**Subject: Genesis Solar, LLC's Petition for Genesis Solar Energy Project  
Docket No. (09-AFC- 8)**

# **Genesis Solar Energy Project Eastern Riverside County, California**

## **Amendment (09-AFC-08)**

**FIGURE 5  
GSEP RING BUS/SWITCHYARD  
VIEW 4**

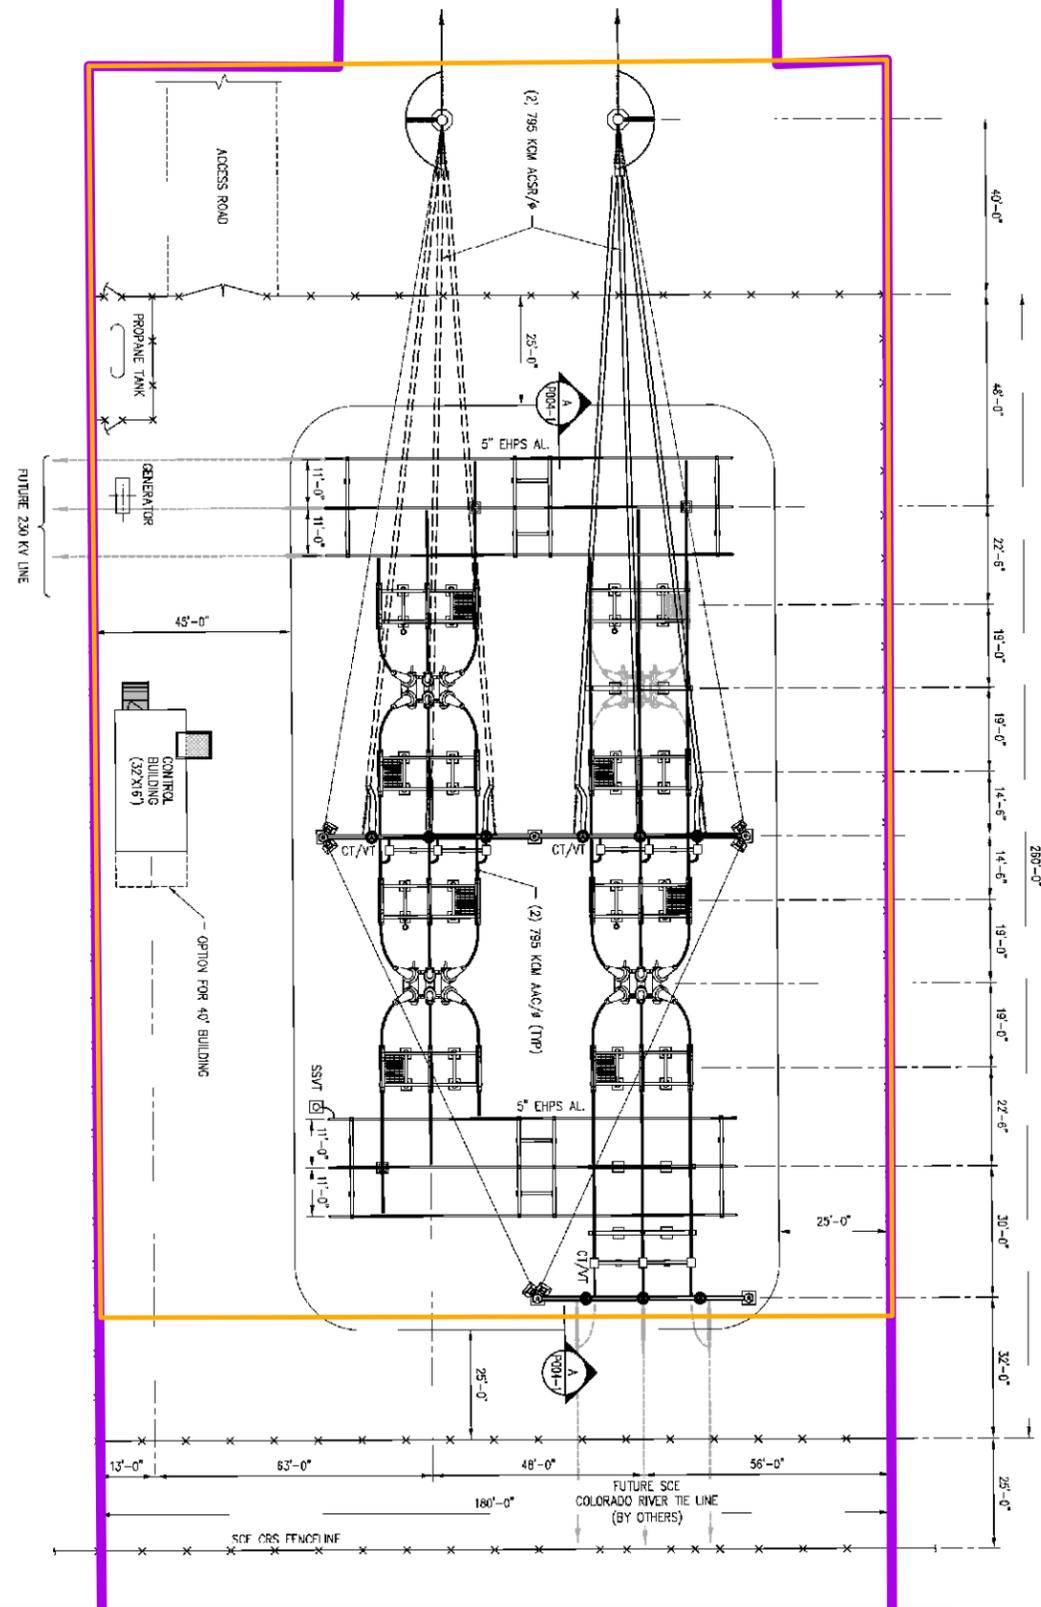
After crossing the BETL, the GSEP double-circuited 230 kilovolt (kV) line will run approximately 1600 ft. to the GSEP ring bus. (See Figure 5, View 4 and Figure 6, One Line Diagram). This stretch includes two new double-circuited 230 kV poles and a ring bus/switchyard structure north of the CRS. Inside the ring bus, will be a new, three-breaker 230 kV switchyard (i.e. no voltage transformation) located 100 ft. north of the northern the CRS perimeter wall (pursuant to SCE offset requirements) and aligned (east-to-west) so as to facilitate a connection to CRS 230 kV Bay 7 while minimizing any impediments to future transmission line connections to other CRS 230 kV Bays

The ring bus connection to the GSEP requires the installation of approximately 1,100 ft. of 230 kV transmission line from the ring bus to the existing GSEP/BETL Joint Use (i.e. Double Circuit) Structures. The ring bus/switchyard will measure 260 ft. long and 180 ft. wide and occupy 46,800 square ft. The total permanent disturbance for the ring bus/switchyard will be approximately 1.58 acres.

Figure 6  
One Line Diagram/Ring Bus

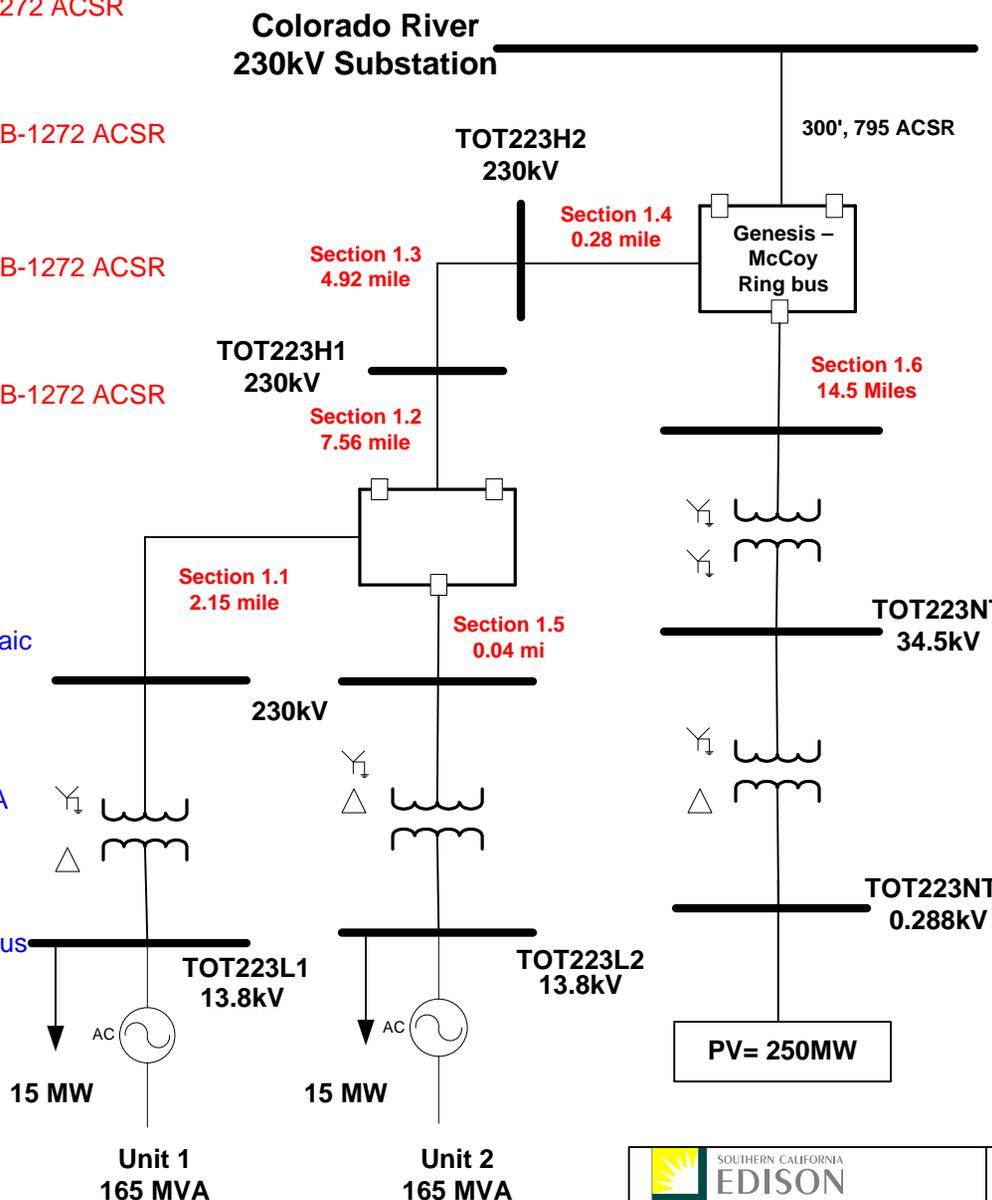
The ring bus/switchyard will also serve to accommodate the various breakers, switches, line protection scheme, RTUs and telecommunication paths for the Special Protection Scheme required under the LGIA. The ring bus will support the full interconnection requirements necessitated by the LGIA and will allow GSEP to operate continually, without interruption, as other phases of the interconnection facilities and network upgrades are completed.
